MINERALS PROGRAM INSPECTION REPORT
PHONE: (303) 866-3567

MINE NAME: Leone Huerfano Gravel Pit	MINE/PROSPECTING ID#: M-2010-004	MINERAL: Gravel and sand	COUNTY: Huerfano
INSPECTION TYPE: Monitoring	WEATHER: Clear	INSP. DATE: July 31, 2024	INSP. TIME: 10:45
OPERATOR: Leone Sand & Gravel LLC	OPERATOR REPRESENTATIVE: Wayne Leone and Brian Brown	TYPE OF OPERATION: 112c - Construction Regular Operation

INSPECTION TOPIC: Gen. Compliance With Mine Plan

Photo 11: Double walled and secondarily contained fuel storage.

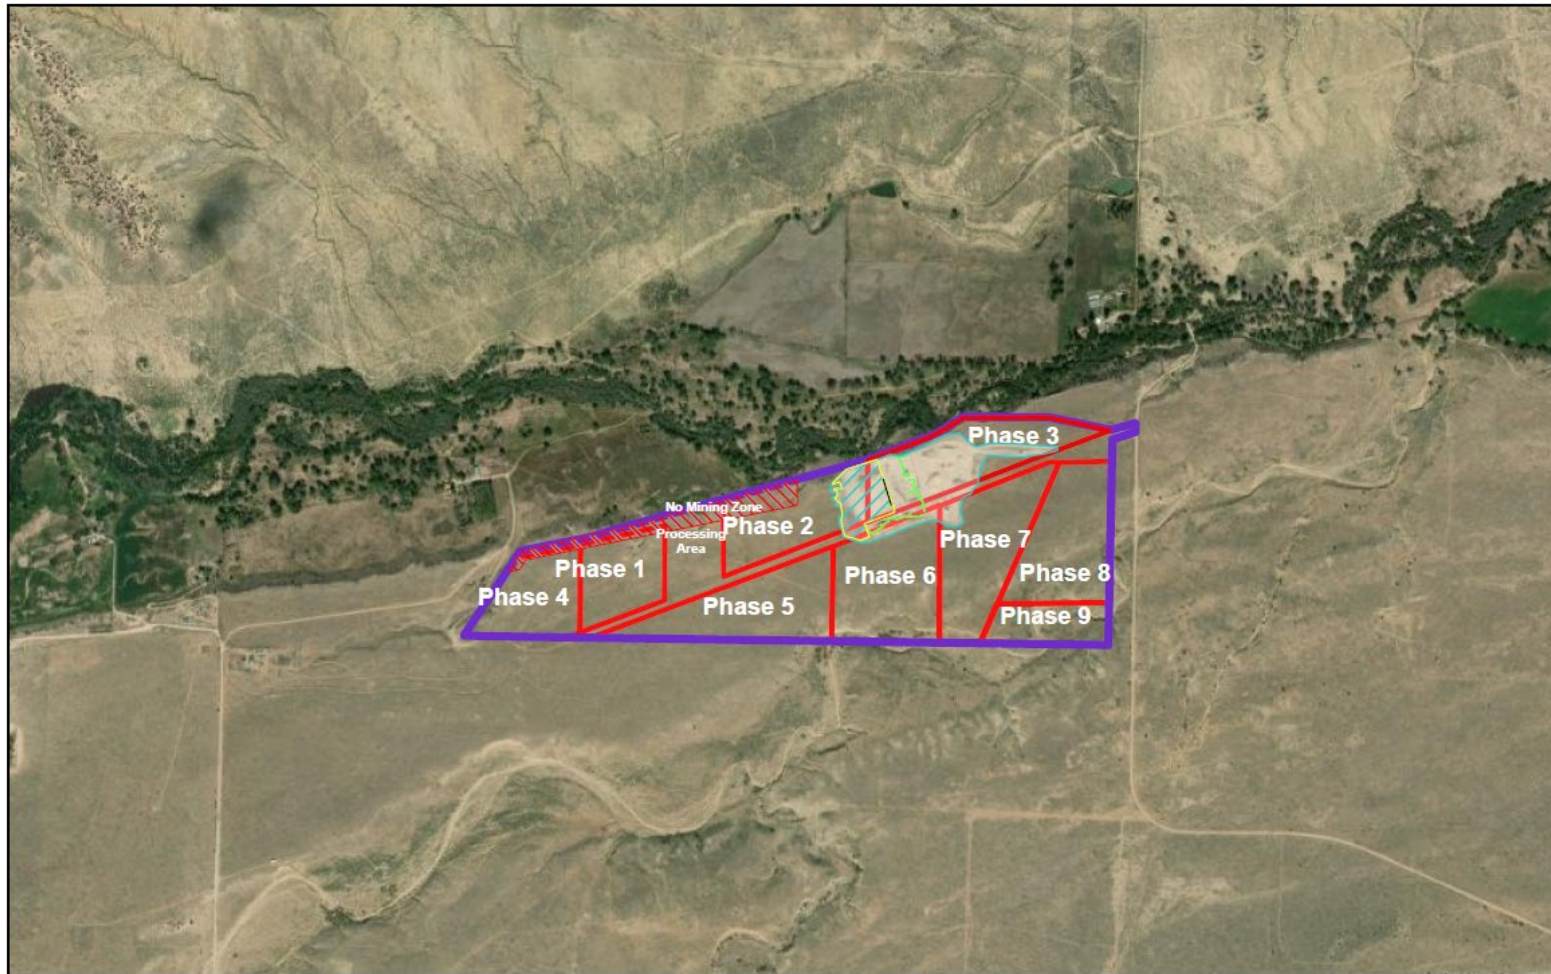
Upon entering the site, the processing area is encountered first. A truck scale, various portable equipment and structures, and product stockpiles (Photo 10) were observed throughout the processing area. As noted in the Division's 2016 and 2020 inspection reports, all above ground fuel storage tanks either had adequate secondary containment or were double walled tanks (Photo 11).

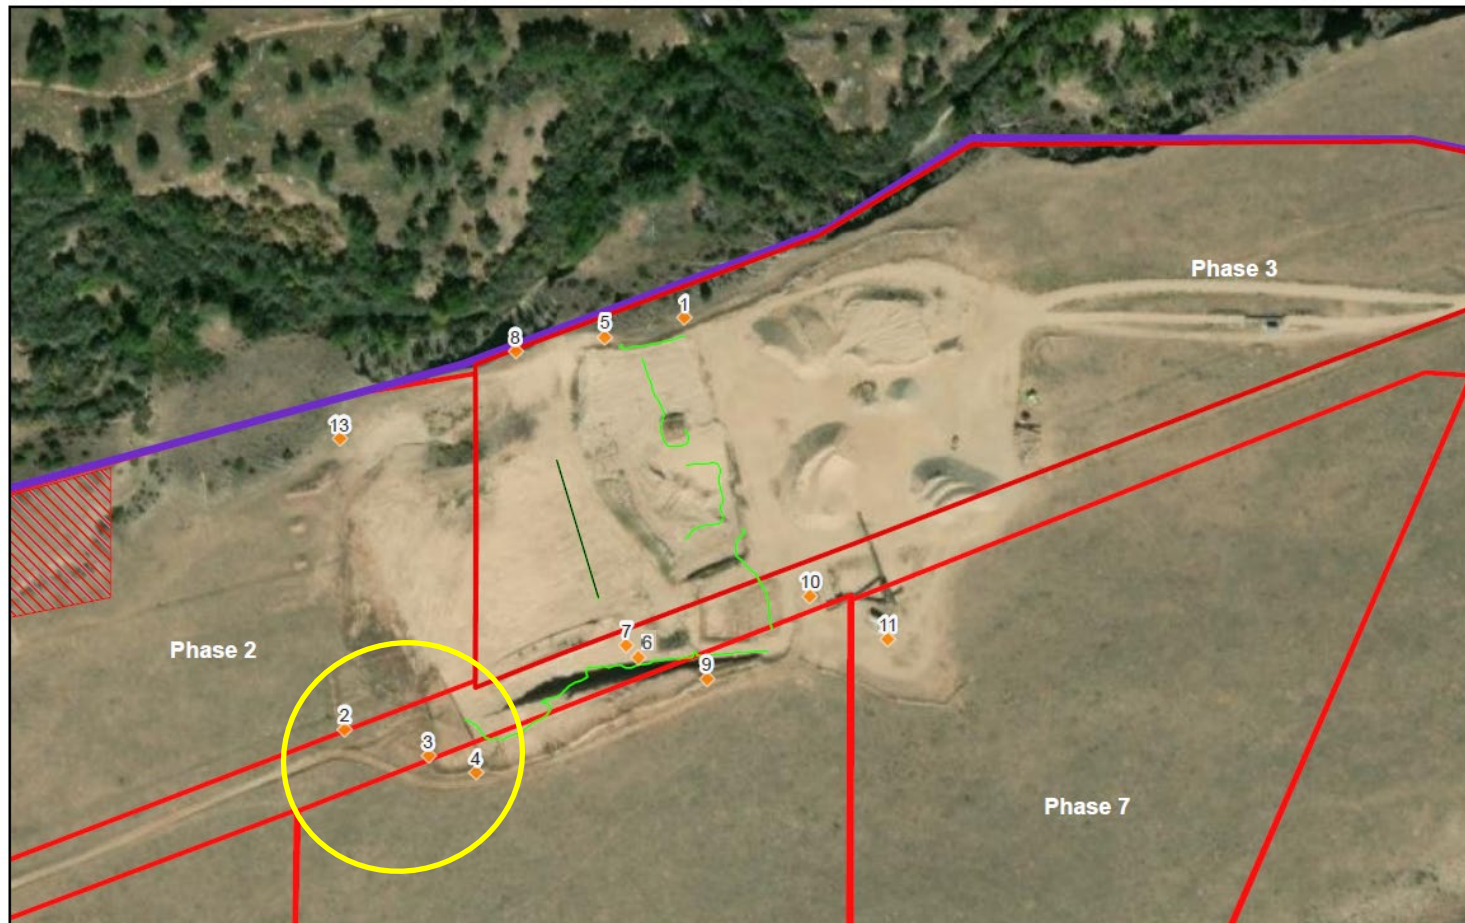
A few problems were identified during the inspection and post-inspection, relating to the currently approved mining plan. It appears that since mining commenced at this site, it has not been conducted in the order nor orientation of the approved phases. The currently approved mining plan states that the site will be mined as an open pit mine consisting of nine phases. The mine plan states that mining would begin in Phase 1, with the processing area to be situated between Phases 1 and 2. From there, phasing would go in numerical order from Phase 2 through Phase 9. Attached to this report is the Approved Mining Plan Map. However, mining appears

to have begun in Phase 3 initially, and has expanded to Phases 2, 6, and 7 (See Maps 1 and 2). The processing area is located in the eastern portion Phase 3, opposed to the currently approved location between Phases 1 and 2.

Additionally, the maximum allowed disturbance is currently limited to 22.5 acres at any time – including haul roads and processing areas. The Division used the Esri Field Maps application to gather measurements for the western and southern extents of the disturbance boundaries and the reclamation boundary (Photos 2-4: Maps 1 and 2). After the inspection, these measurements were synced to ArcOnline and used in combination with recent aerial imagery to calculate area measurements of the disturbance boundaries (see polygons on Map 2). The Division estimates that approximately 35.27 acres are currently disturbed, including approximately 9.22 acres of unreleased reclaimed areas.

The Operator has conducted contemporaneous reclamation throughout the life of the mine. During this inspection, approximately 9.22 acres of the 35.27 currently disturbed acres have been backfilled, graded, and seeded (See Maps 1 and 2; Photo 8). The reclaimed slopes have been graded to a slope flatter than 3H:1V. The Operator has been mining the pit walls while purposefully maintaining a buffer between the disturbance boundary and the permit boundary, as to better facilitate using a cut-fill method to backfill slopes upon reclamation.

These issues have been collectively **cited as a problem above**. **The Operator shall submit a technical revision to update the mining plan and mining plan maps to reflect the current and anticipated mining operations, the current and anticipated road configurations (see Roads section below), maximum allowed disturbance acreages, and maximum highwall lengths by the corrective action date.**

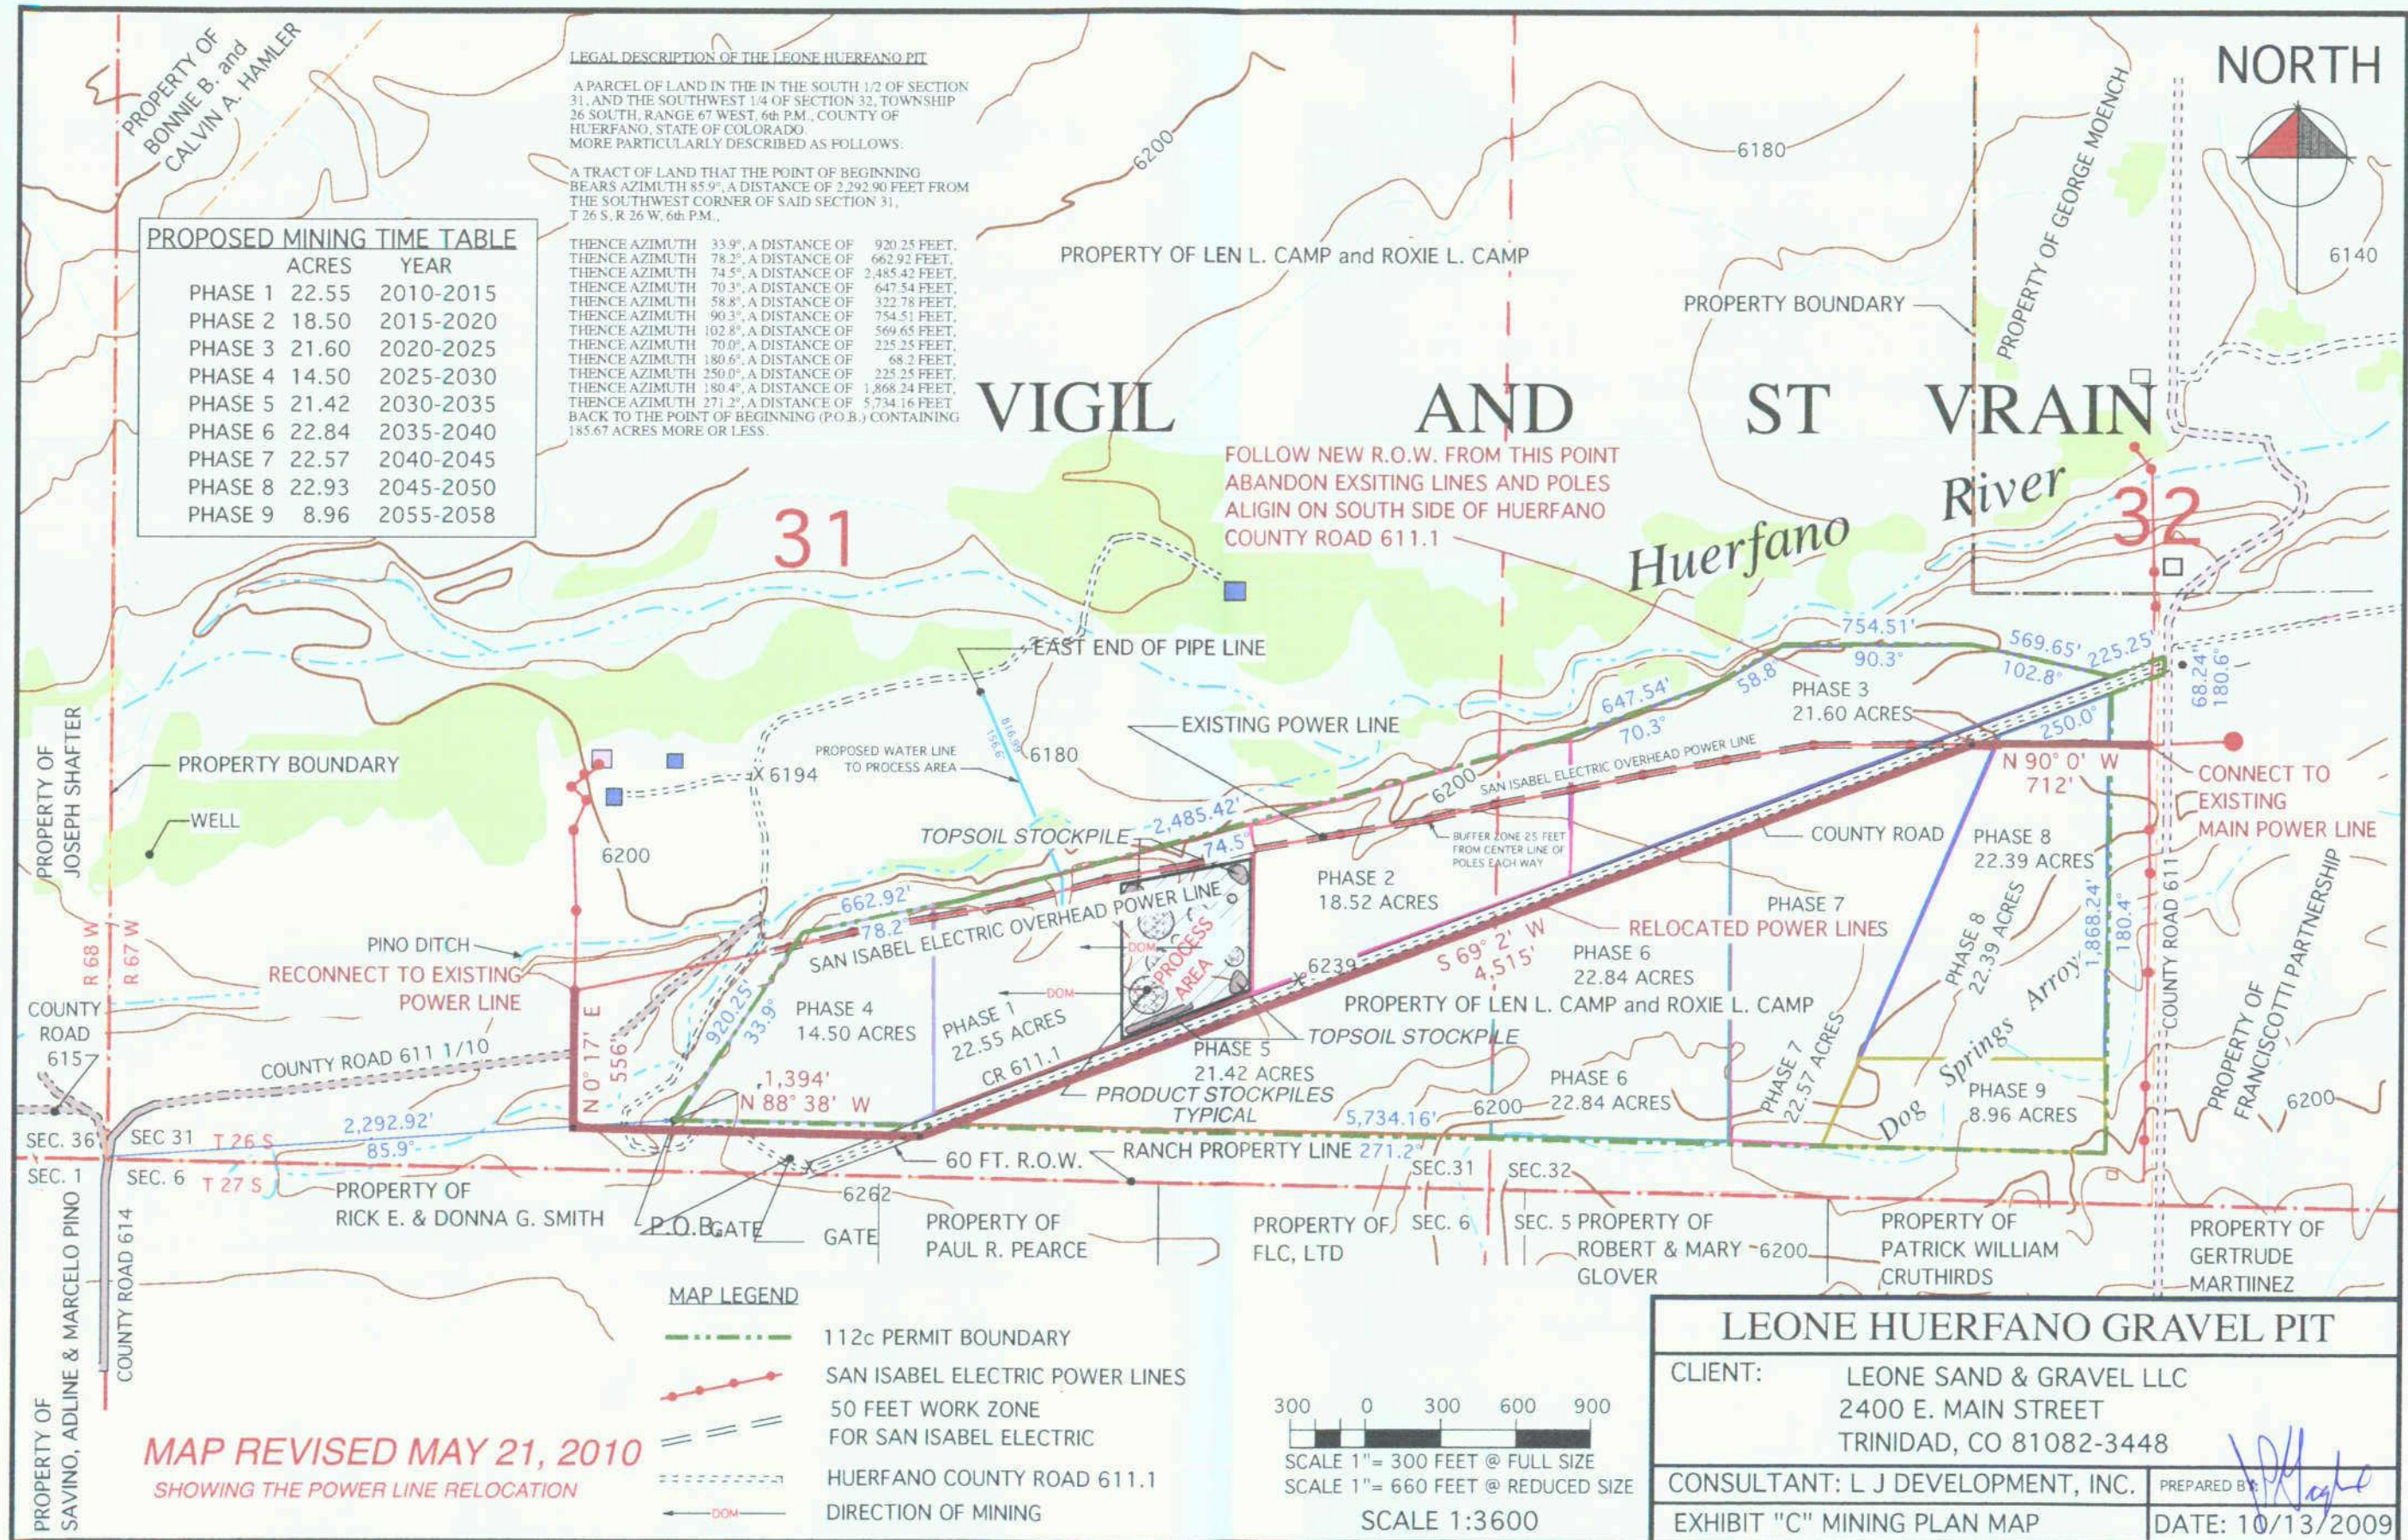
The maximum depth of excavation was increased to 40 feet, through the approval of Technical Revision 1 (TR1), from the previously approved 18 foot maximum. Highwalls onsite range from a small section of approximately 6-8' high, 1H:1V slopes to a series of 1H:1V slopes ranging from ~20-40' high (Photos 5-7: Map 2). The highwall/pit heights appear to be in compliance with the currently approved plan, but the highwall length has far exceeded the 400' maximum length approved through TR1. The Division walked the lengths of the highwalls and collected measurements with the Field Maps application, and estimates that the total current highwall length is approximately 1,454 feet (Map 2).

Topsoil stockpiles were observed along the western disturbance boundary (Map 2). Topsoil has been stripped and placed outside of the pit boundaries, and out of the way of ongoing mining disturbance, in compliance with Rule 3.1.9(3). Overburden piles were also observed along the northern and southern boundaries of the pit, separated from the topsoil stockpiles, in compliance with Rule 3.1.9(1). Topsoil has been systematically used to reclaim the slopes in the areas of the pit that have been deemed as mined-out. The current stockpiles have volunteer vegetation growing on them and appear stable (Photo 13).
